RE: *Comments from Tetra Tech: Medway Mill, 163-165 Main Street, Medway, MA*

On behalf of our client, NRG Concept Inc., Guerriere & Halnon, Inc. has prepared the following information to address the comments contained in the letter from Tetra Tech dated March 19, 2020.

Color Renderings of Existing/Proposed Bridge Construction
Medway Mills 163-165 Main Street
Date: May 14, 2020

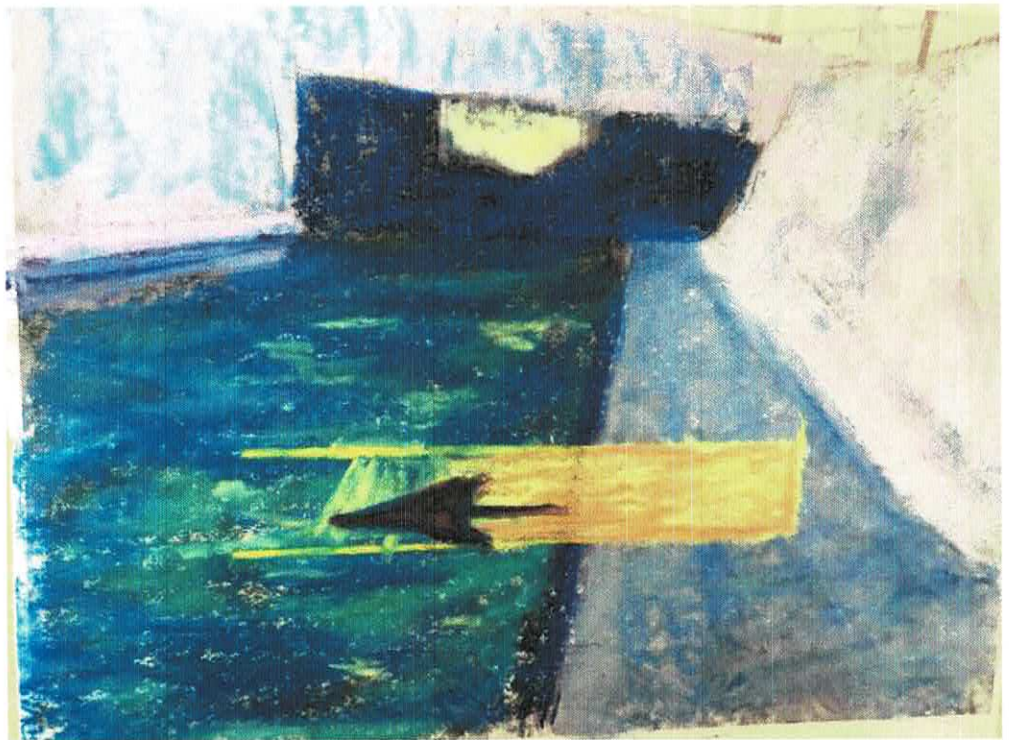
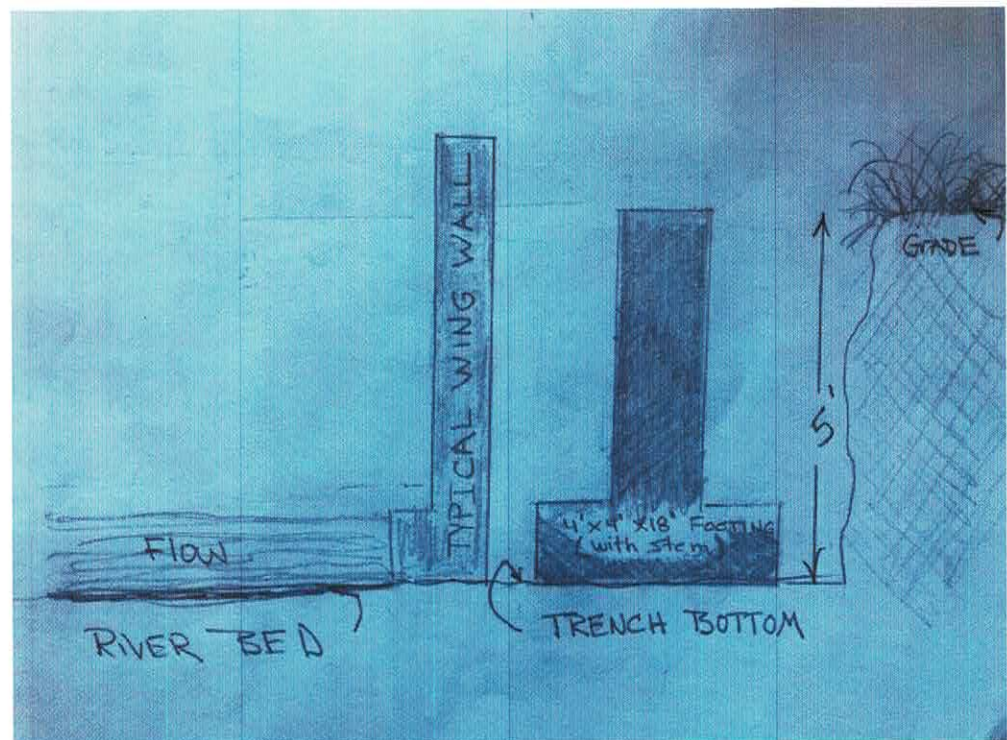
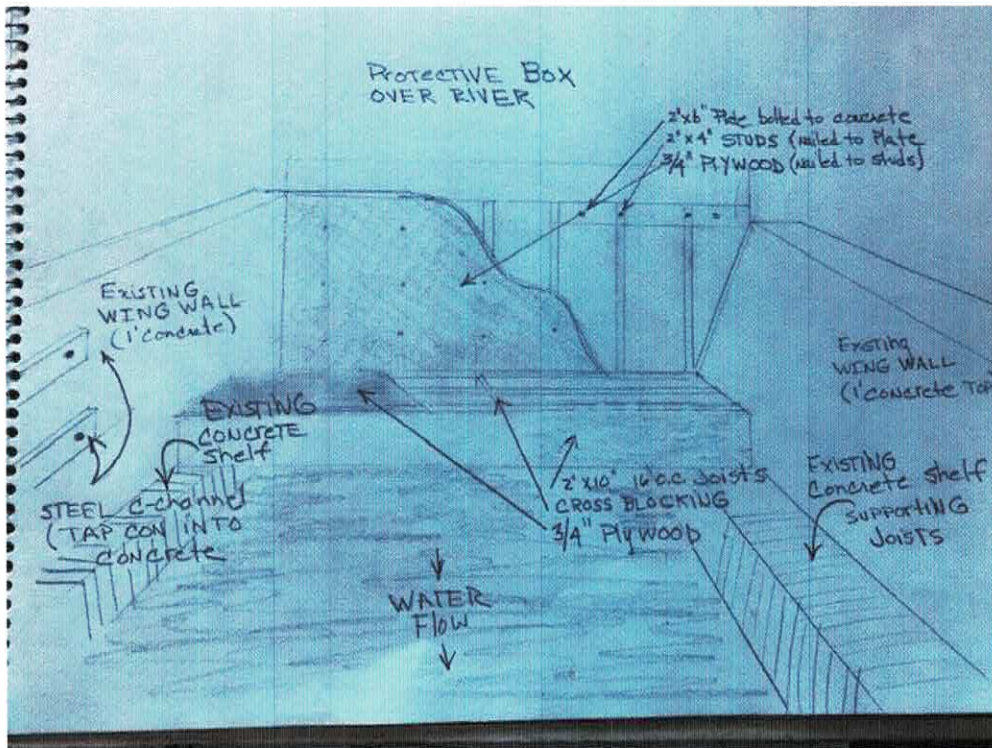
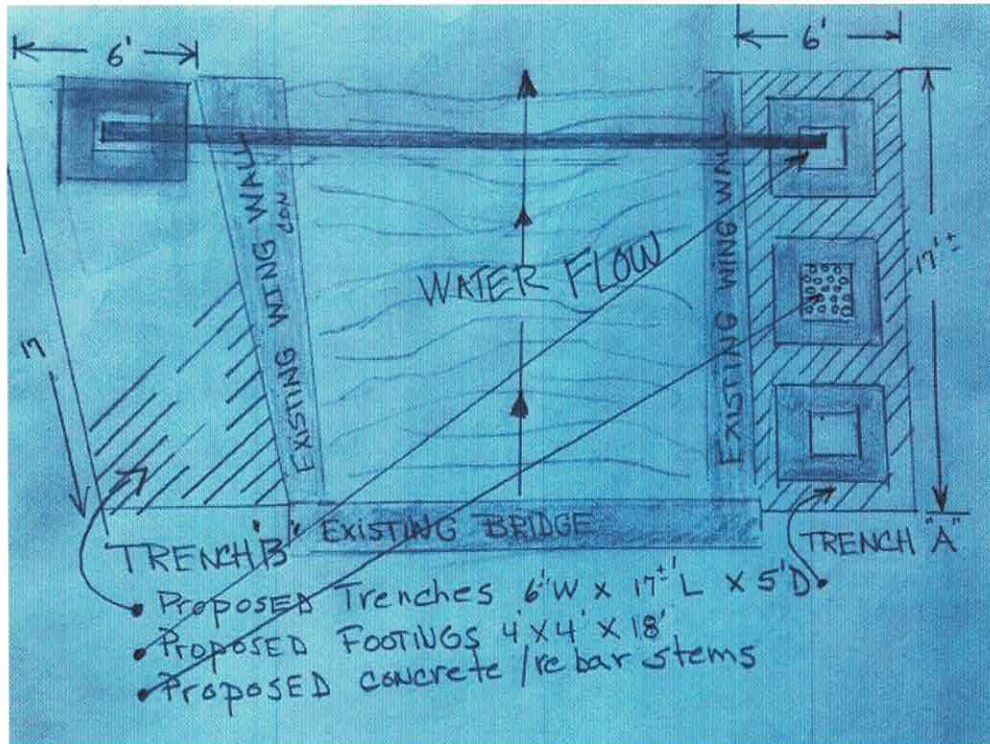
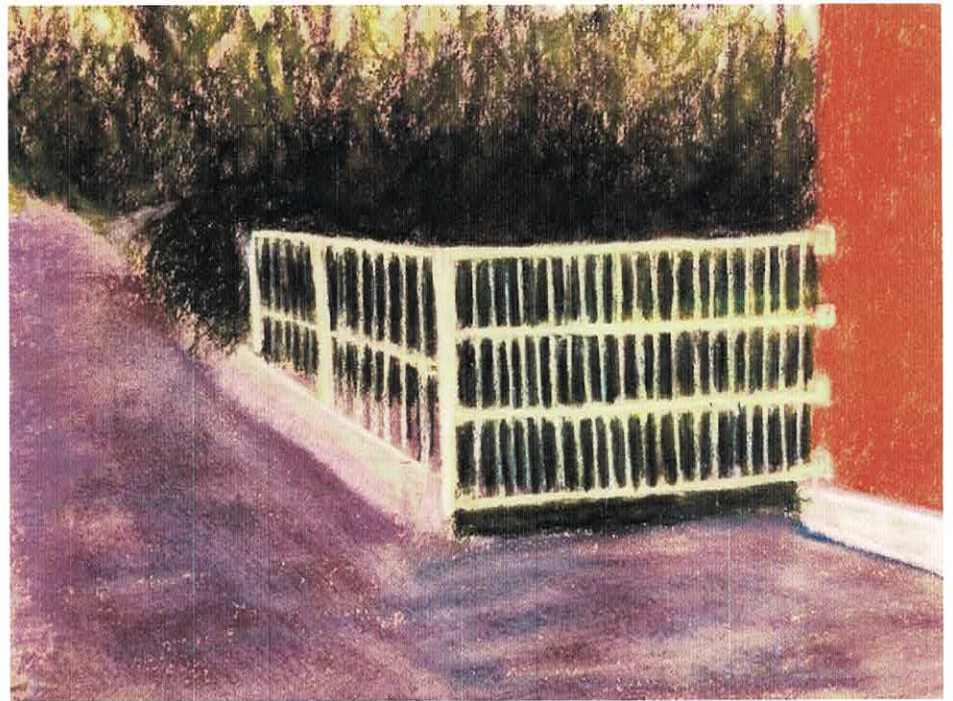
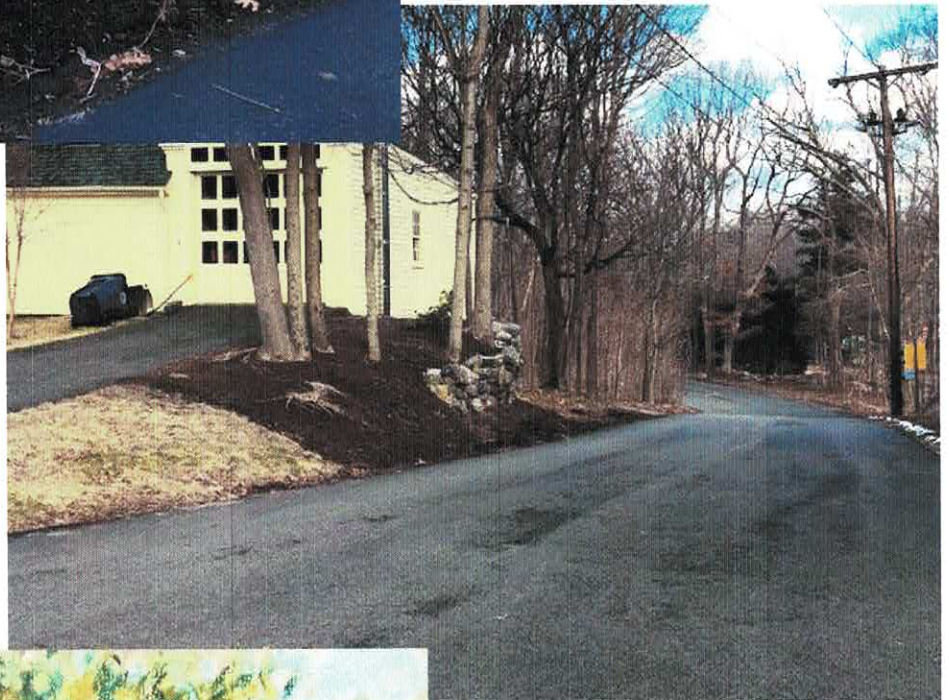
37. *Details of the proposed bridge expansion should be included in the Plans to determine extent of impact to the site.*

GH: Bridge to be designed by others upon site plan approval. Color renderings provided as reference.
